Mapleton City Council Staff Report

Consideration of Final Plat approval for the Silverado Plat "A" subdivision consisting of fourteen lots located generally at 500 West 1600 South, and a request for a Transferable Development Right Receiving Site overlay zone.

MAPLETON CITY DEVELOPMENT REVIEW COMMITTEE MINUTES

Project: Silverado Subdivision

22' Street Cross Section
A-2 Zone Rural Local Street
1200 South Street

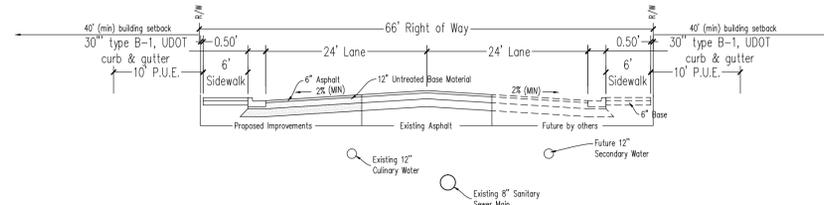
1. The 1200 South Street cross section on page C-5.0 calls for a "half plus five" street cross section, a cross section that includes 21' of ROW dedication. The plat shows a 16' street dedication and a 6' street dedication in two separate notations. This creates confusion as to what the dedication is and must be clearly noted on the final plat.

32' Street Cross Section
A-2 Zone Rural Local Street
(500 West Street)

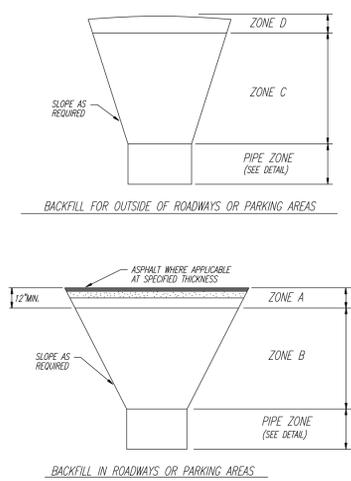
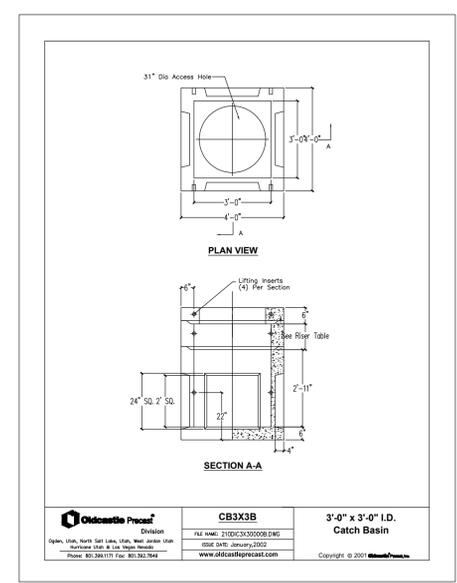
2. Details on pages P-2, P-3, P-4 and C-5.0 make reference to a 34' street cross section that is actually only 32' wide. To avoid confusion these references must all be consistent with the 32' cross section.

MAPLETON CITY CORPORATION
Standard Drawing Addendum
PRESSURIZED IRRIGATION-01
ADOPTED JULY 2010

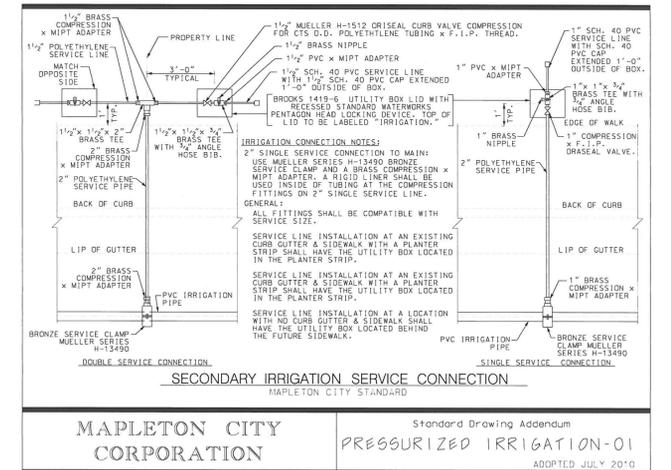
1. Removal of abandoned water main on 1600 South may be required to place 12" PVC C900 Pressurized Irrigation Main.
3. Show Pressurized Irrigation-01 Detail for pressurized irrigation service with Pressurized Irrigation Service Meter Detail for PI meter box on Sheet C-50. The one shown is the old drawing.
3. Show 8-inch minimum for all Pressurized Irrigation Pipe on Street Cross-Sections.

Sheet No.
P - 1

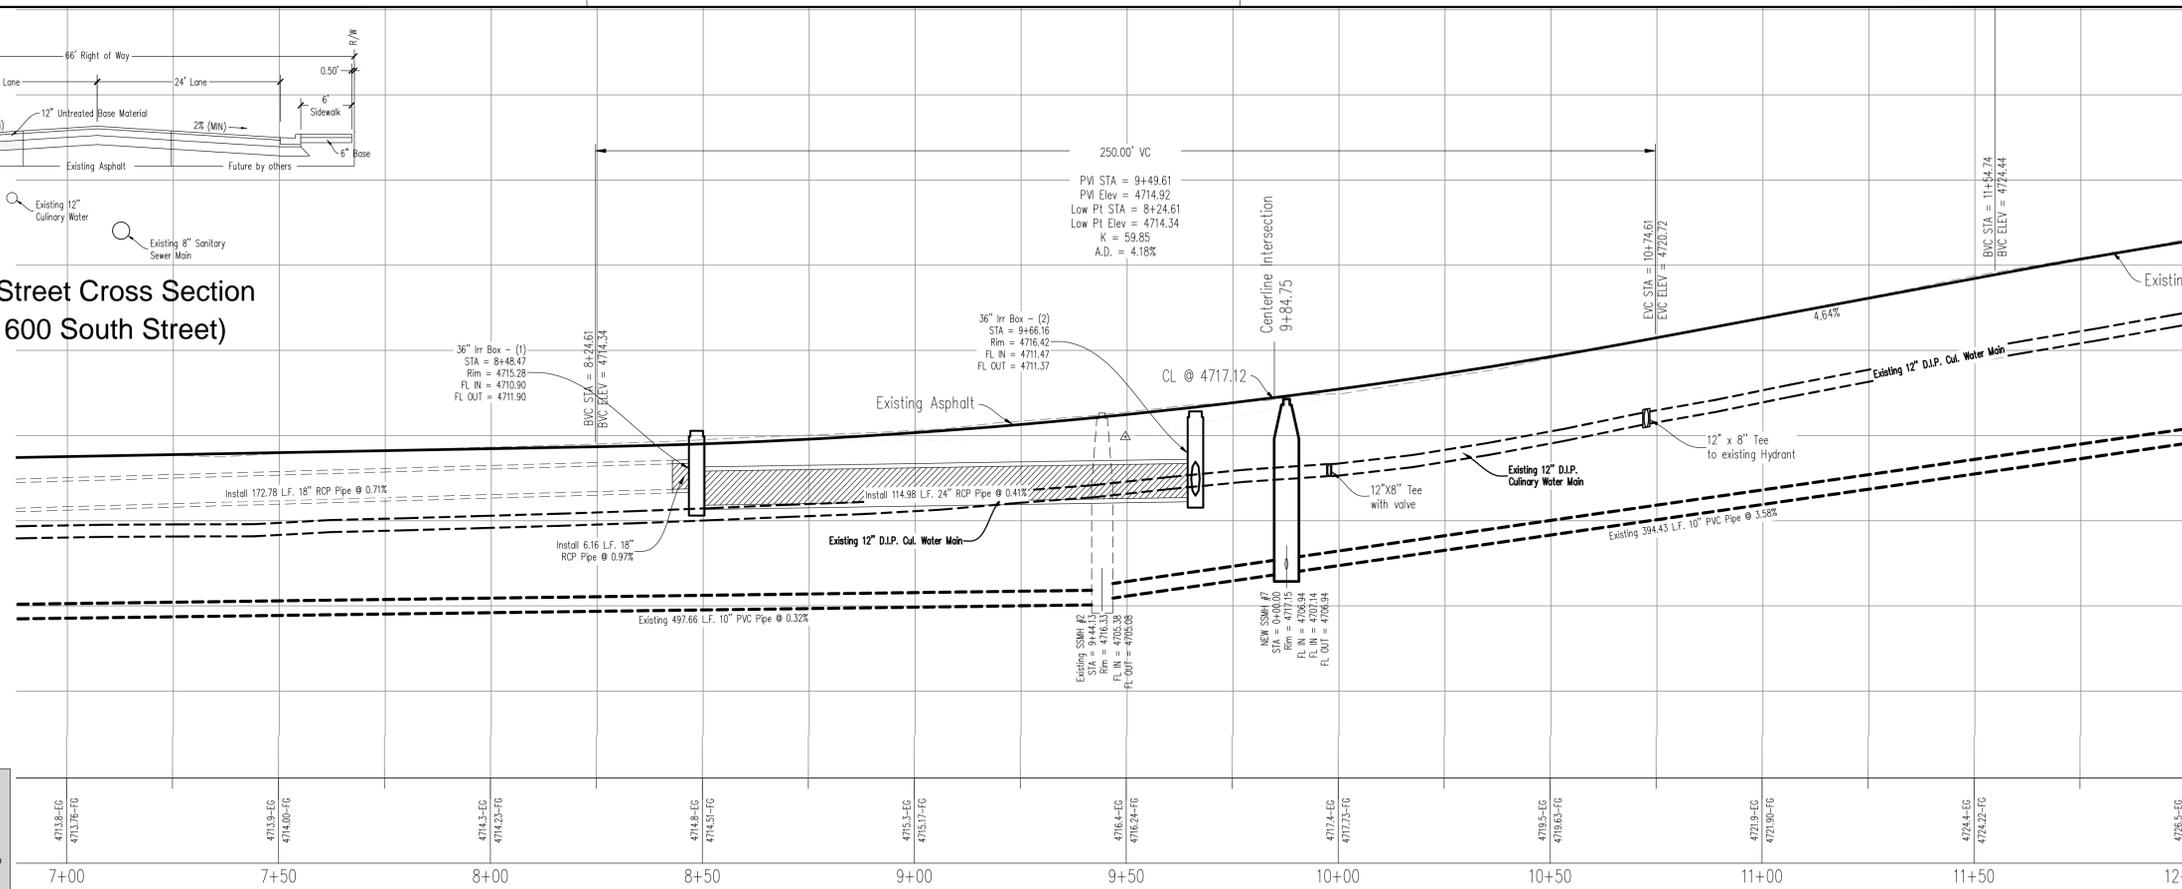
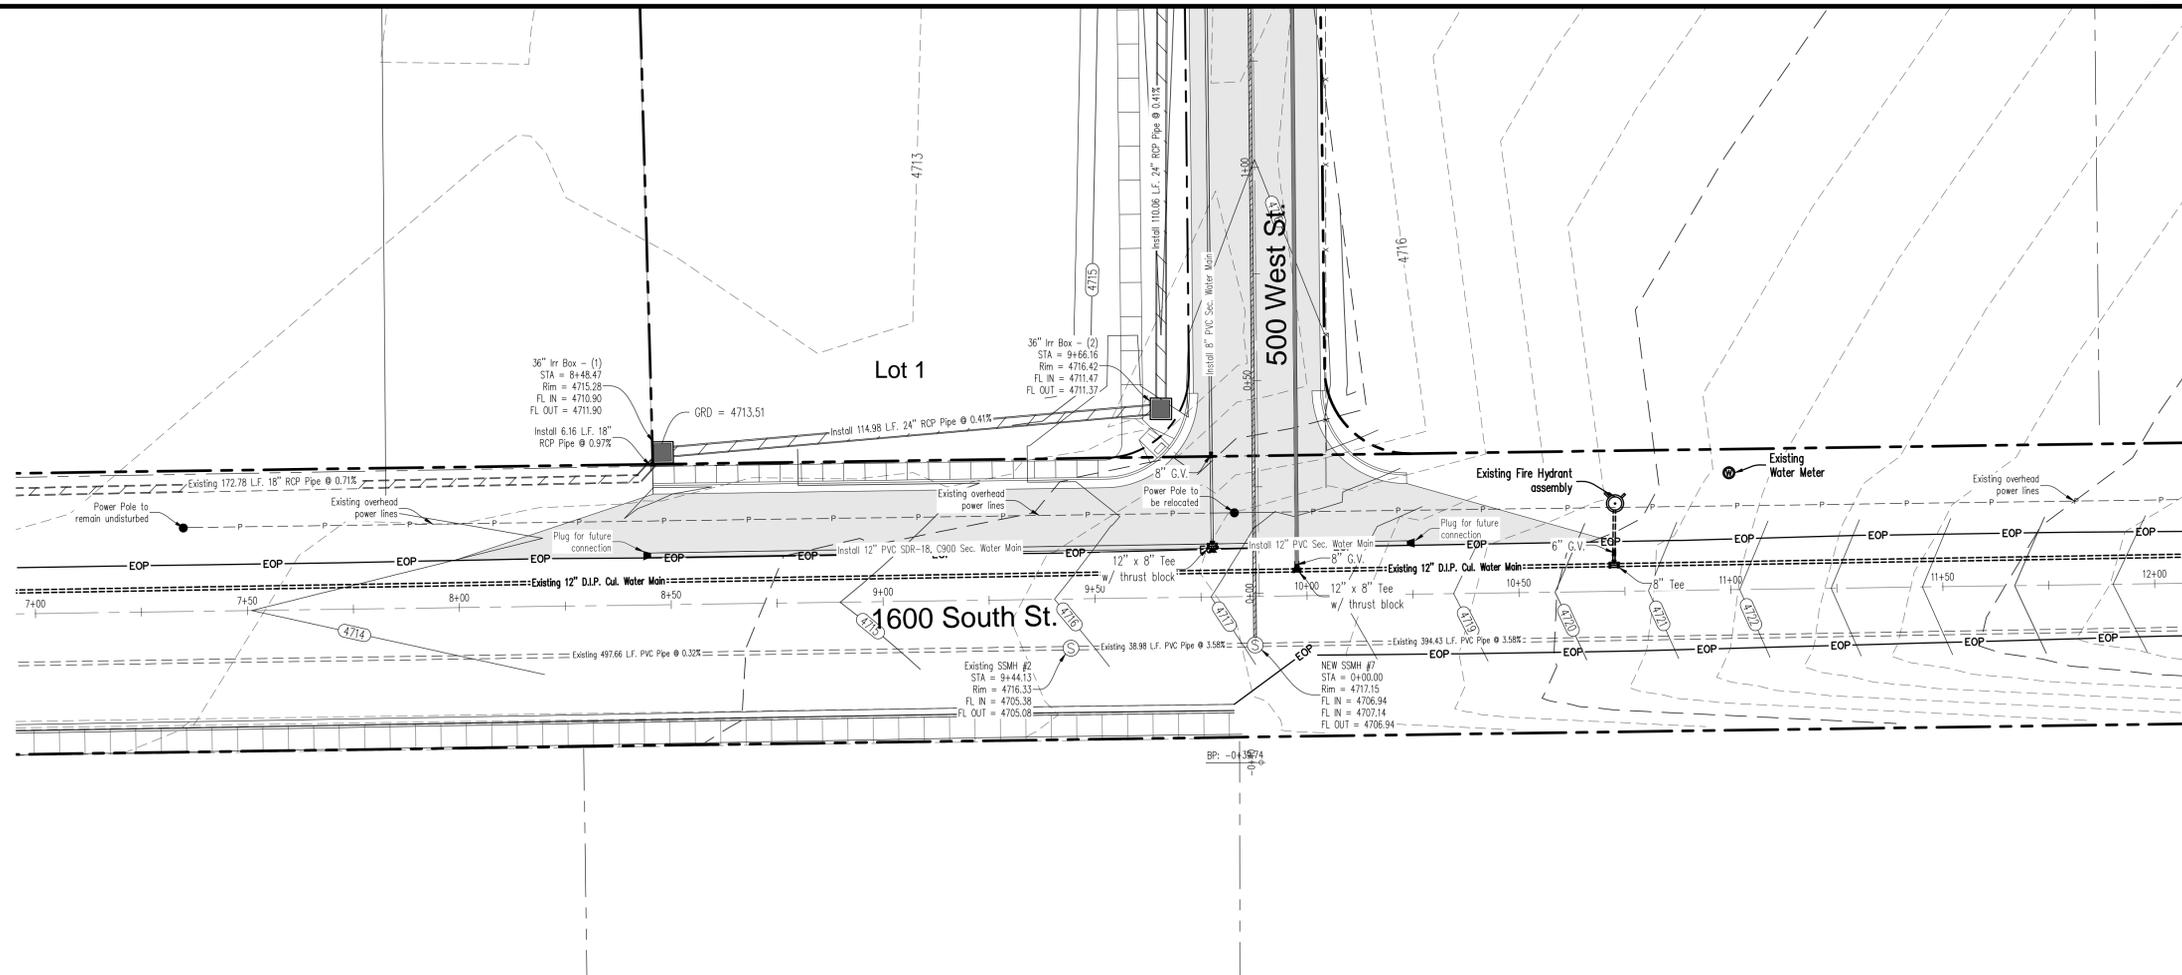
1. Show Plan and Profile Drawings. Show existing ground profile legibly on all sheets.
2. Change Existing Sewer Main 1600 S. from a 8-inch 10-inch (See Sheets No. P-1 and P-2)
3. Minimum 8-inch sewer slope is 0.00334. This slope will save 2 feet of fill on the east end of 1200 West Street.
